**Response to the U.S. Nuclear Regulatory Commission  
Request for Additional Information Regarding the  
Preliminary Safety Analysis Report and Environmental Review of the  
Northwest Medical Isotopes, LLC  
Construction Permit Application Docket No. 50-609**

**Dated: September 29, 2016**

**(Document No. NWMI-2016-RAI-004, November 2016)**

**Figure 1. Offsite Dose Calculation of Spray Leak Accident as a Function of Distance**

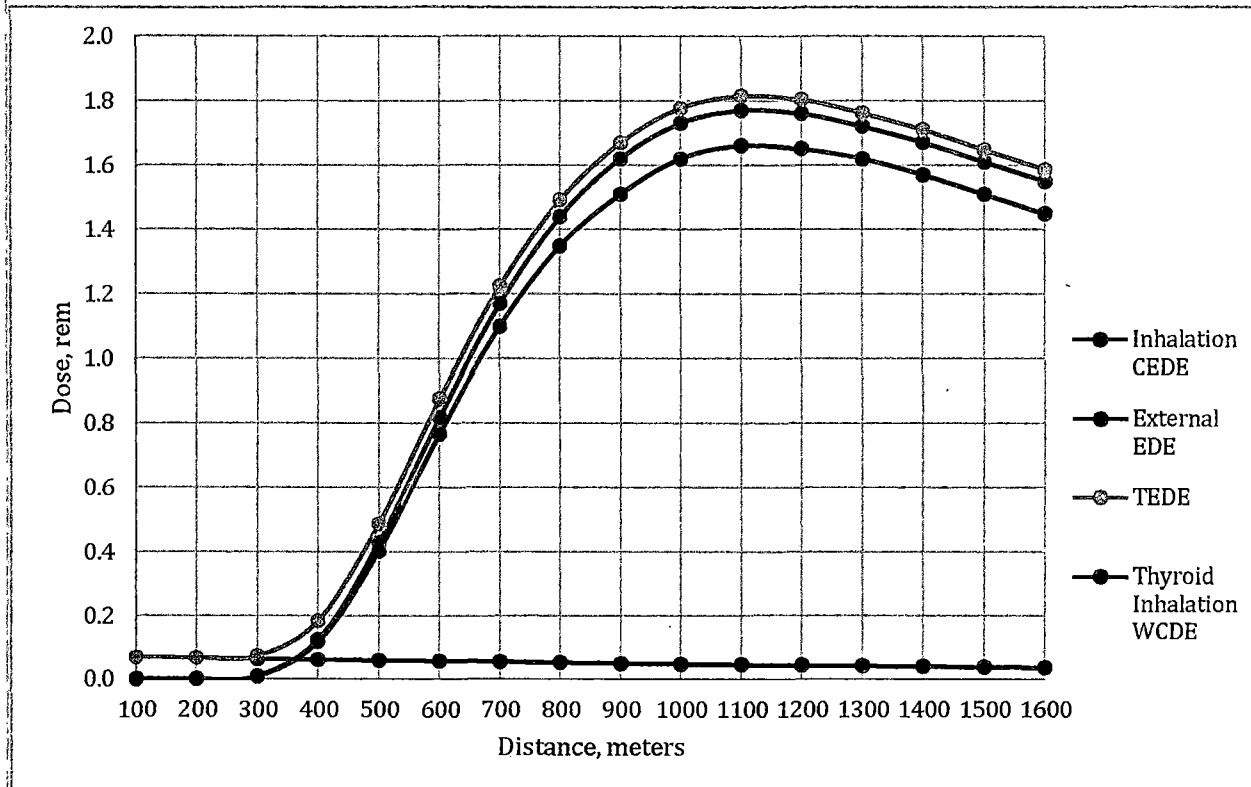
<p>The data in Figure 13-2 of PSAR Section 13.2.1 is in units of TEDE. The labels on the figure will be corrected.</p>	
<b>RAI 13.2-4</b>	<p><i>The ISG Augmenting NUREG-1537, Part 1, Section 13b.2 states that the radiation dose estimates should include estimates for the operating staff throughout the event and during recovery operations and also for the maximally exposed individual in the uncontrolled areas and at the nearest permanent residence.</i></p> <p><i>NWMI PSAR Section 13.2.2, “Liquid Spills and Sprays with Radiological and Criticality Safety Consequences,” describes the accident scenario and presents the calculated TEDE dose results in PSAR Table 13-24, “Spray Release Consequence Summary.” PSAR Table 13-24 identifies the maximum unmitigated TEDE dose as 12 rem to the public. PSAR Section 13.2.2.7.2, “Confinement Release Consequence,” contains a discussion of the mitigated dose consequence value of 0.97 rem to the public. No results or discussion is provided pertaining to operating staff dose or dose to the public at the nearest permanent residence. The location of the nearest permanent residence is not identified.</i></p>

No.	Request for additional information
RAI 13.2-4 (cont)	Provide results and discussion pertaining to operating staff dose, including worker stay time. Identify the location of the nearest permanent residence and provide results and discussion pertaining to the dose to the public at the nearest permanent residence.

In the Construction Permit Application, NWMI originally used both RASCAL and RSAC to model off-site accident consequences. Since the submission of the application, NWMI has selected RSAC for off-site accident consequence modeling. For the liquid spills and spray accident in PSAR Section 13.2.2, NWMI has rerun the off-site dose calculations using RSAC. The nearest permanent resident (432 m [0.27 mi]) unmitigated dose estimate is 300 mrem, while the maximum receptor location (1,100 m [0.68 mi]) has a TEDE of 1.8 rem (Figure 1).
